## **ZONING CHANGE REVIEW SHEET**

CASE: C814-2018-0121 -- 218 South Lamar

This report includes all comments received to date concerning your planned unit development (PUD) request. The PUD will be brought to public hearing when all requirements identified in this report have been addressed. However, until this happens, your rezoning request is considered disapproved.

4-Lane Divided, 60' Curb-to-Curb  
Back-of-Curb Condition F  
Barton Springs Road to Riverside Drive

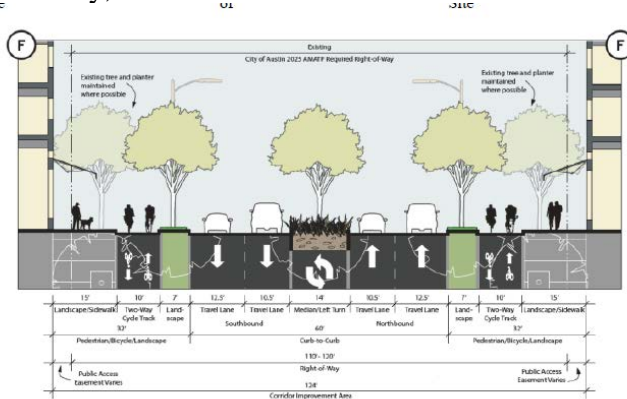
TR2. Include the below streetscape in the land use plan. Contact this reviewer for a more legible copy of it if necessary. This project is adjacent to a street that has been identified in Austin's Corridor Mobility Program (S Lamar). The sidewalk and bicycle facilities shall comply with the required cross-section at the time of the site plan application. The cross section that will be required is shown below. Find additional information about the Corridor Mobility Program here: <https://data.austintexas.gov/stories/s/Corridor-Mobility-Program/gukj-e8fh/>. Any proposed curb relocations on S Lamar requires coordination with the Corridor Planning Office and Bicycle Program. The cross section will include a 7' planting zone with street trees, a 10' two-way cycle track, and a 15' clear zone all behind curb. Additionally, a protected intersection will be required at Toomey, to be reviewed at the time of Site Plan.
